Access Compliance Report

Public Rights-of-Way

(Curb Ramps)

Intersection ID: 8535	Main Street: BROOKSHIRE_BV	Cross Street: NELSON_AV	Location: NW
ADA ID: 836425E55E0B	Ramp Type: Perp	Initial Pass/Fail: Fail	Overall Compliance: No
Severity Score: 33.75			
Codes/Mitigation Info/Possible Solution		Field Measurements/Component Compliance

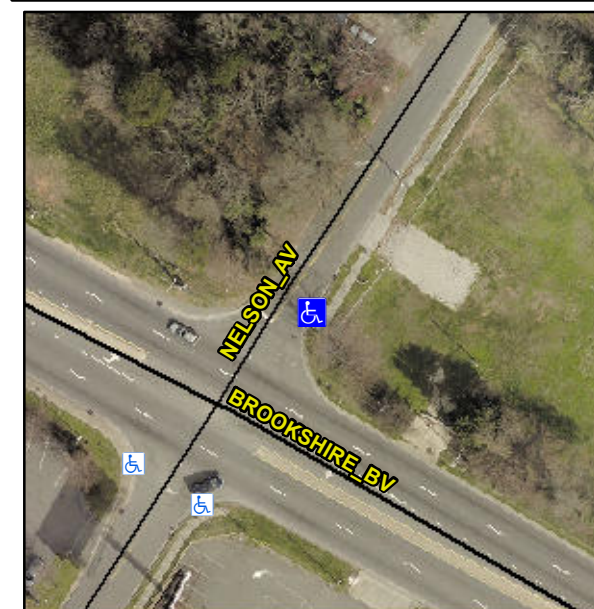
Not Found, R304.5.1, R304.5.3

Compliance	Description	Data	Compliance	Description	Data
N/A	Ramp Length (in)	52.0	Yes	Ramp Slope (%)	5.4
No	Ramp Width (in)	46.0	No	Ramp XSlope (%)	11.1
N/A	Flare Type LT	N/A	N/A	Flare Type RT	N/A
N/A	Flare Slope LT (%)	N/A	N/A	Flare Slope RT (%)	N/A
N/A	Flare Traversable LT?	N/A	N/A	Flare Traversable RT?	N/A
N/A	Landing Length (in)	N/A	N/A	DWS Provided?	N/A
N/A	Landing Width (in)	N/A	N/A	DWS Contrast?	N/A
N/A	Landing Slope (%)	N/A	N/A	DWS Length (in)	N/A
N/A	Landing X Slope (%)	N/A	N/A	DWS Full Width?	N/A
N/A	Landing Curb? (Y/N)	N/A	N/A	DWS Offset (in)	N/A
N/A	Shared Landing?	N/A			
N/A	Gutter Ponding?	N/A	N/A	Gutter Slope (%)	N/A
N/A	Gutter Lip Ht (in)	N/A	N/A	Gutter X Slope (%)	N/A
N/A	Painted X Walk1?	No	N/A	Painted X Walk2?	N/A
	X Walk 1 Direction	To W		X Walk 2 Direction	N/A
N/A	X Walk 1 Width (in)	N/A	N/A	X Walk 2 Width (in)	N/A
	X Walk 1 Slope (%)	5.4		X Walk 2 Slope (%)	N/A
	X Walk 1 X Slope (%)	7.9		X Walk 2 X Slope (%)	N/A

Remove & Replace Entire Ramp.
